CHARLOTTE - MECKLENBURG PLANNING COMMISSION
INTER-OFFICE COMMUNICATION

SUBJECT: Administrative Approval for Petition 2002-103, APS Investments, LLC.

Project: TUFFY AUTO SERVICE CENTER
9841 ROCKY RIVER RD. - CHARLOTTE, NORTH CAROLINA
Title: COVER SHEET
File #: 052510W Date: 12/9/05
Project Egr: BTU
Design By: BTU
Drawn By: MAO
Scale: 1"=60'
8720 RED OAK BOULEVARD, SUITE 420
CHARLOTTE, N.C. 28217
PHONE (704) 527-3440 FAX (704) 527-8335
CO.0

SUBJECT: Administrative Approval for Petition 2002-103, APS Investments, LLC.

TUFFY AUTO HARRISBURG

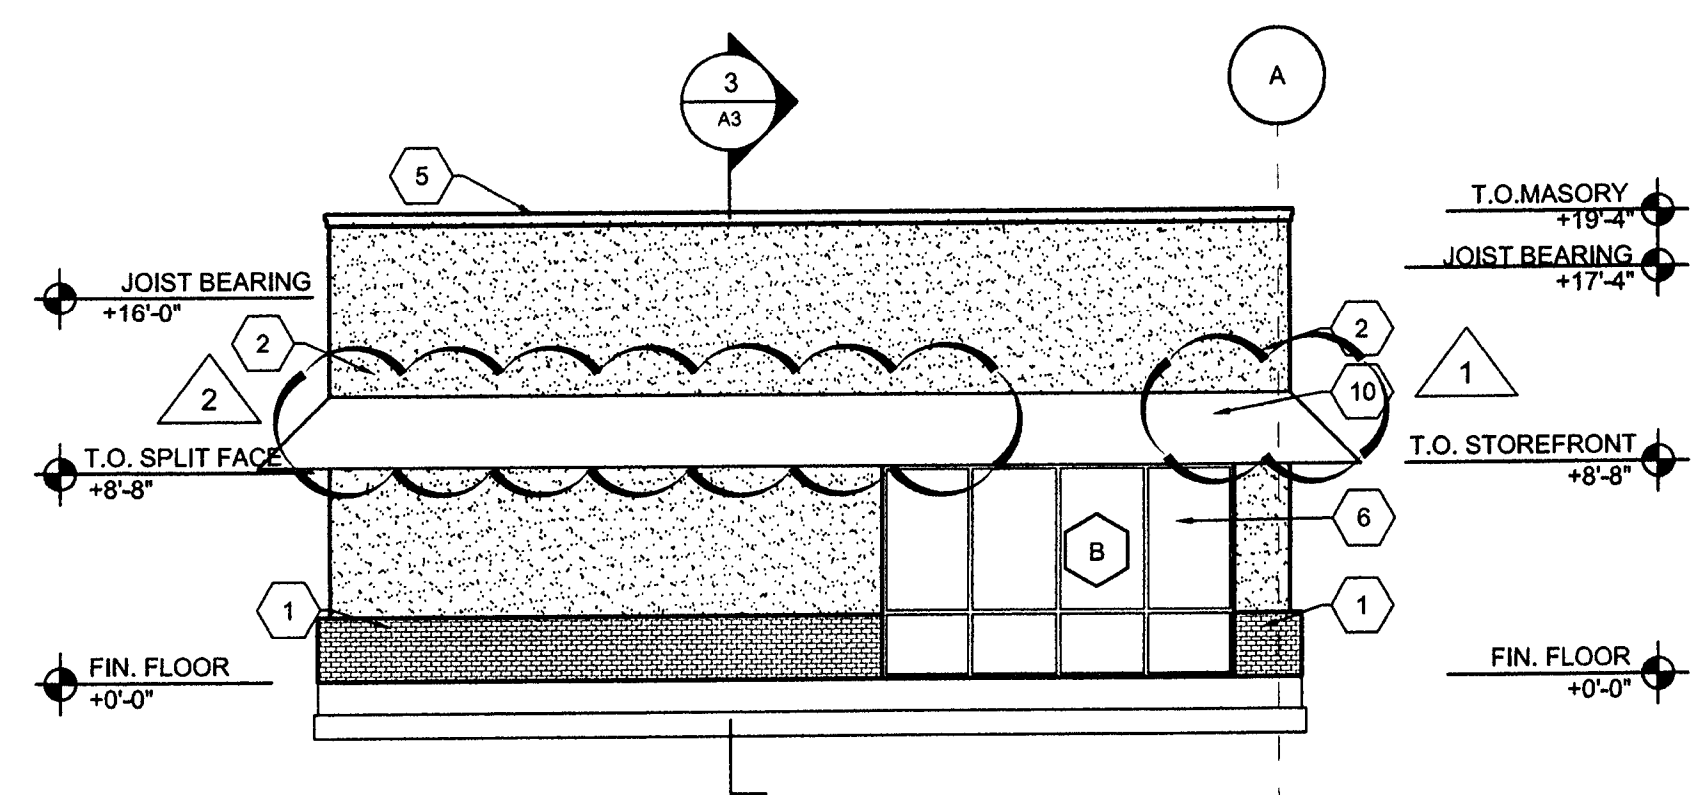
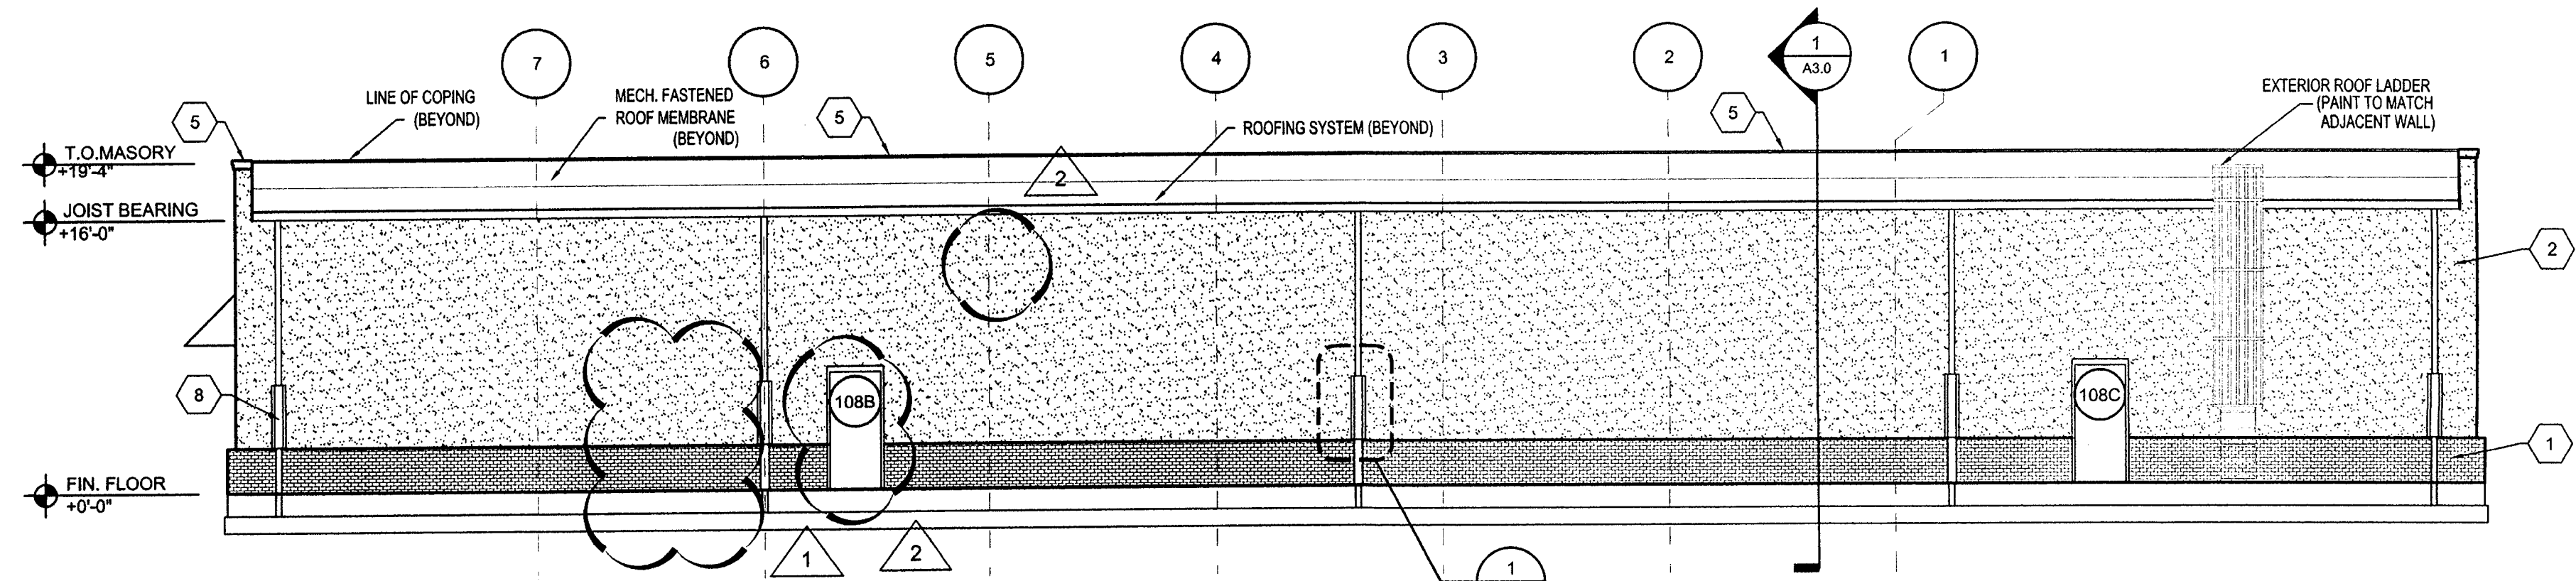
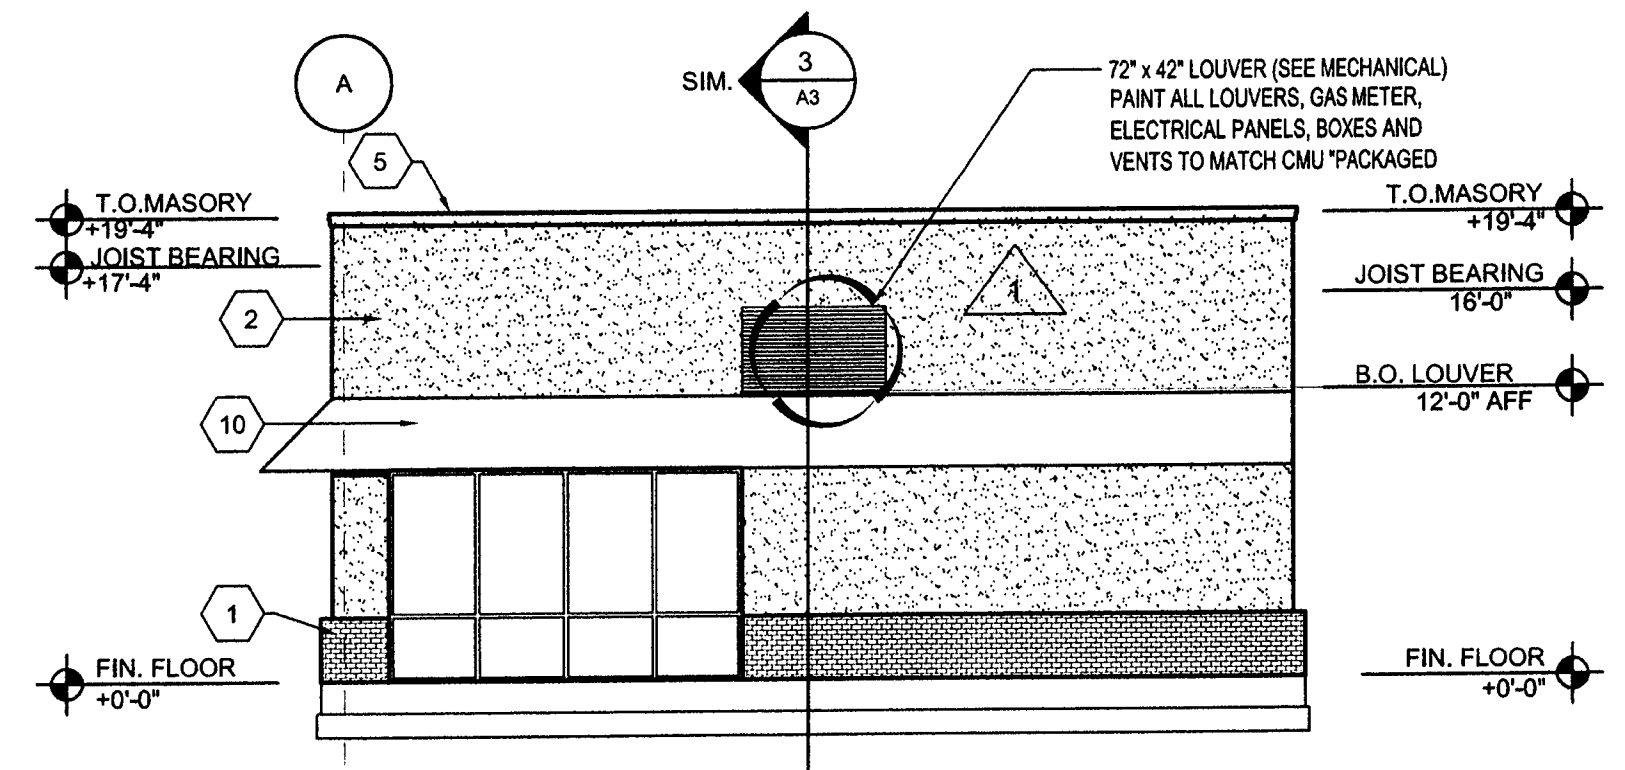
3
REVISION 3 INCLUDES CHANGING FACE OF BUILDING TO BRICK AND STUCCO.
